Re: Wastewater Treatment Plant Improvements Project
HRC Recommendation Letter for Change Order 03

CWSRF 5825-01
HRC Project 20221119

CHANGE ORDER NO.: 03

Owner:	City of Grand Ledge	Owner's Project No.:	5825-01
Engineer:	Hubbell, Roth & Clark	Engineer's Project No.:	20221119
Contractor:	RK Davis, Inc.	Contractor's Project No.:	C760
Project:	Wastewater Treatment Plant Improvements	Effective Date of Contract	6/11/2025
Contract Name:	Wastewater Treatment Plant Improvements		
Date Issued:	3/24/2026	Effective Date of Change Order:	3/24/2026

RAW WASTEWATER
LIFT STATION
PLANS

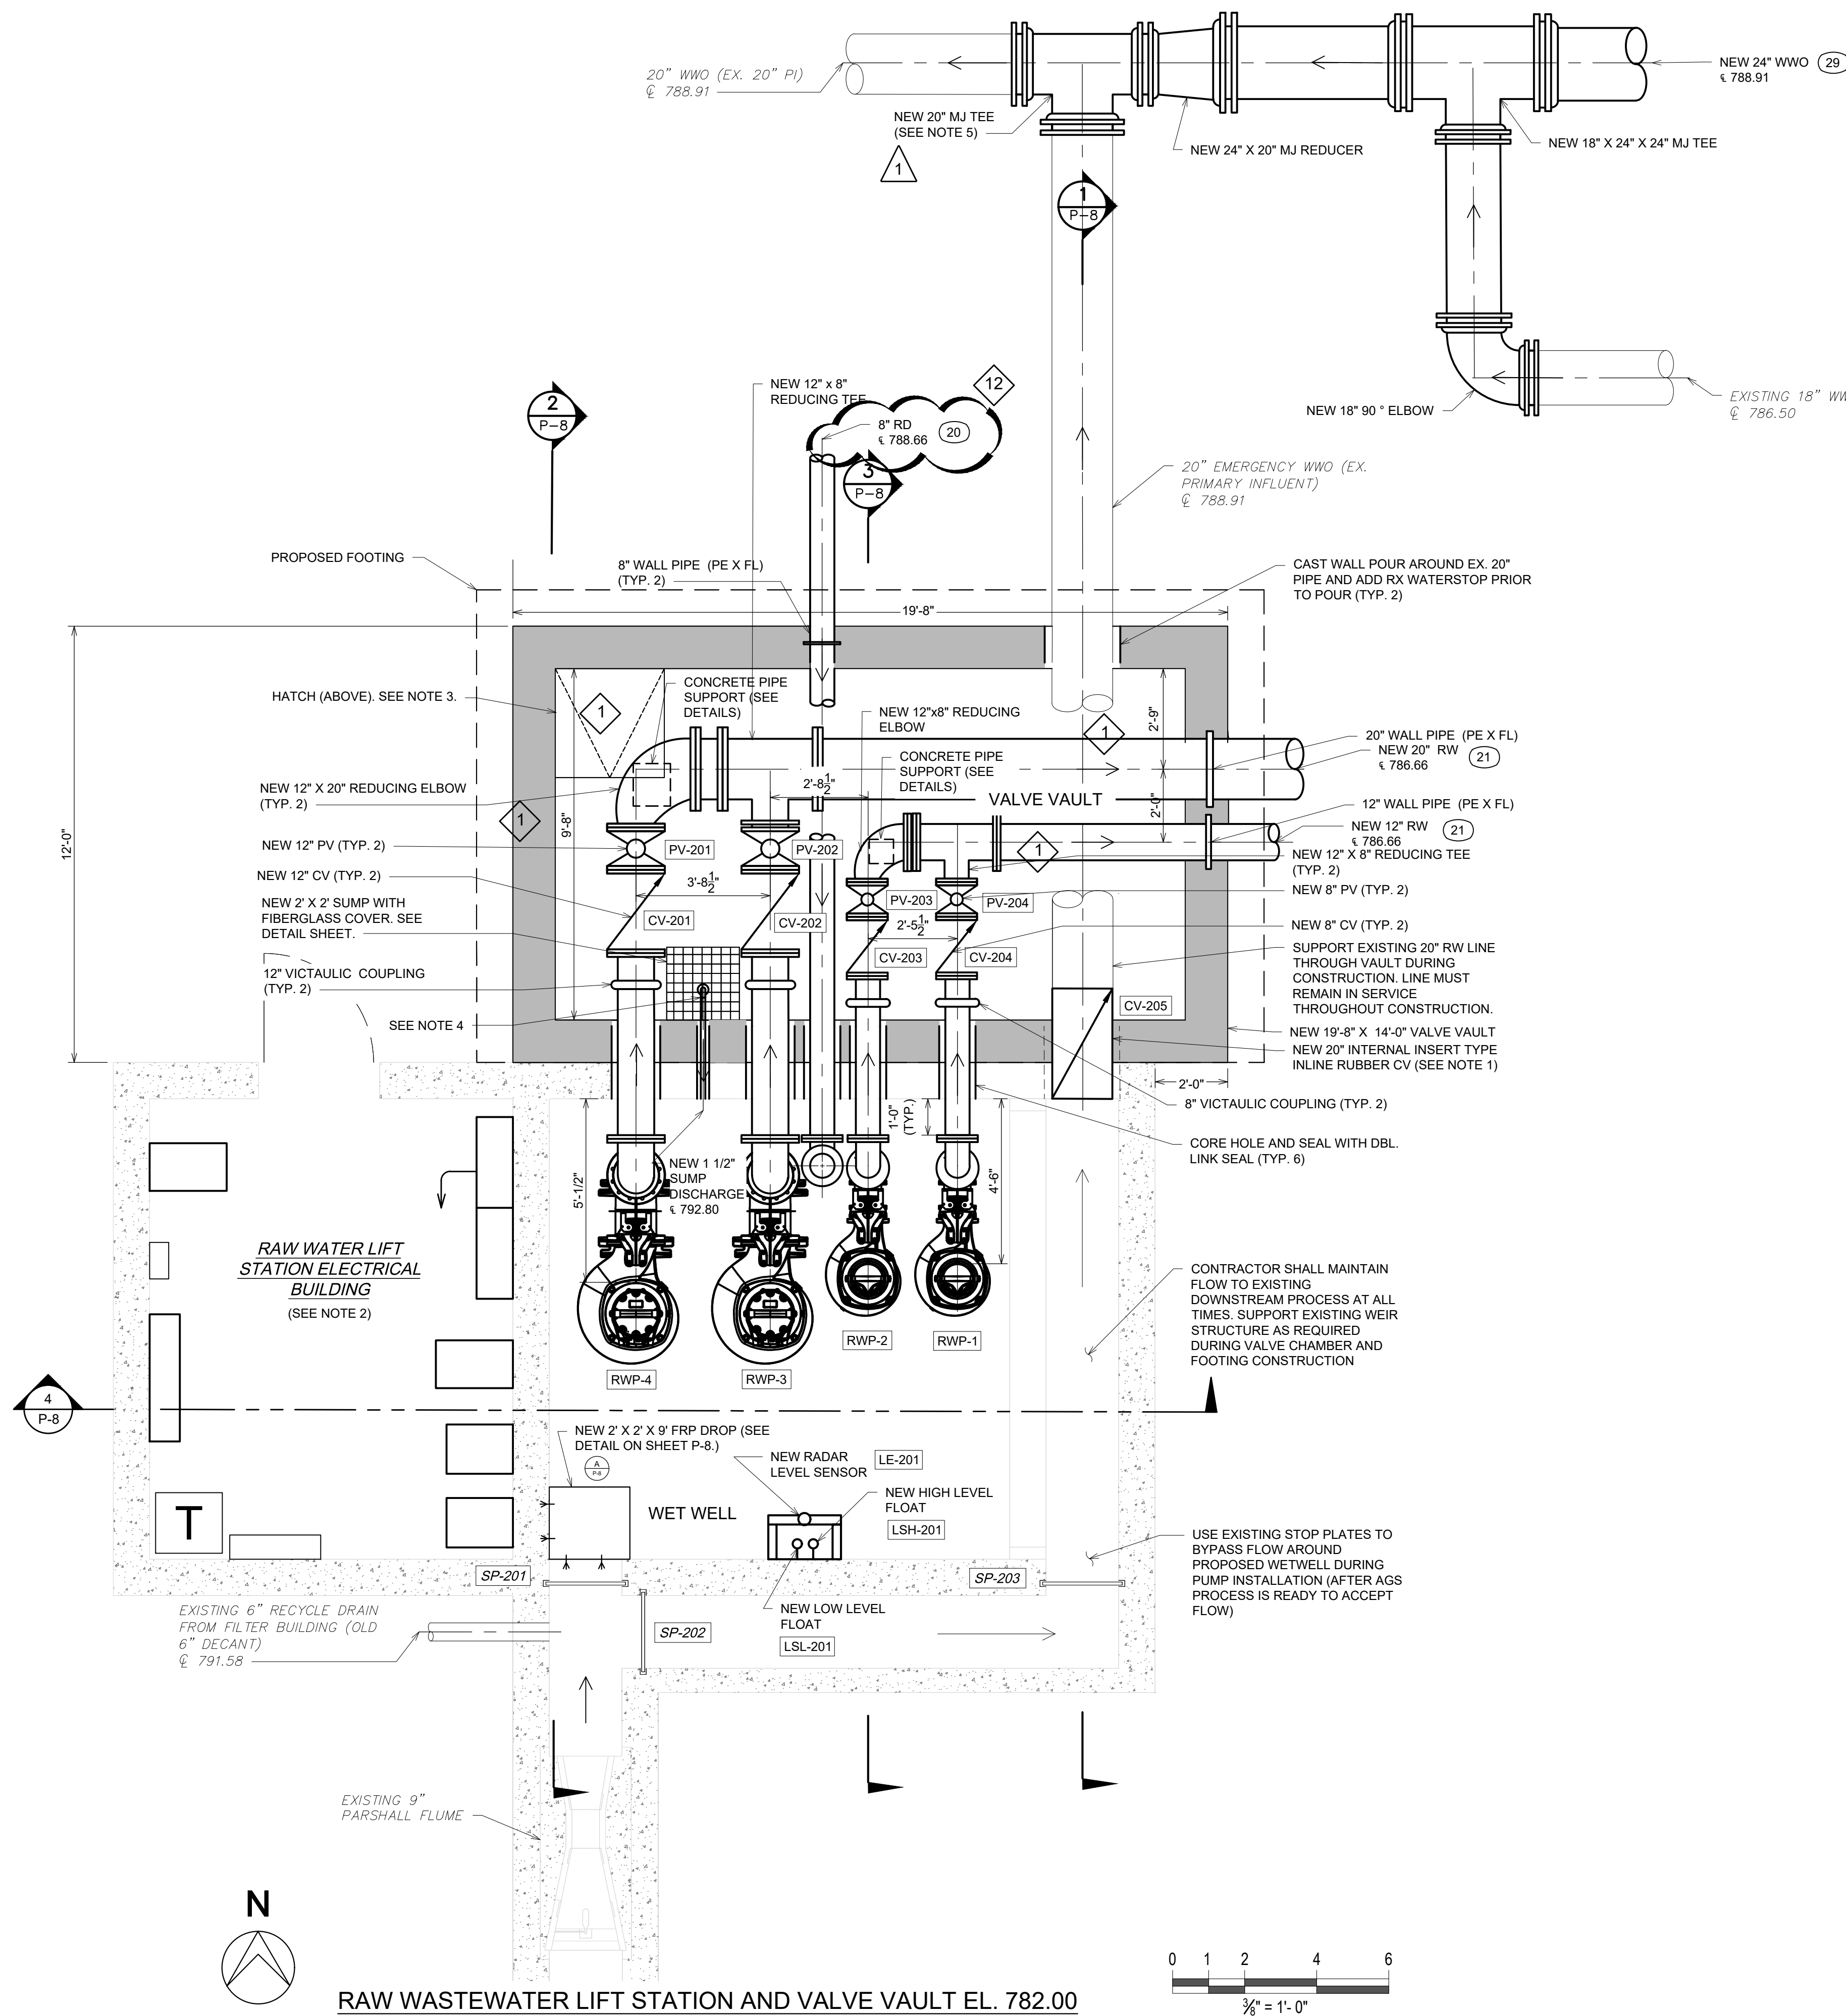
FIELD ORDER NO.: 12
RAW WASTEWATER LIFT STATION 8" DRAIN ELEVATION REVISION

Based on field verification from the contractor, the duct bank elevation is 791.28 top and 789.25 bottom. Revise pipe centerline elevation for the 8" DR line in the Raw Wastewater Lift Station from 790.33 to 788.66 to avoid the existing electrical duct bank.

1. Install two 45 degree bends fittings south of the upstream manhole to achieve the elevation change
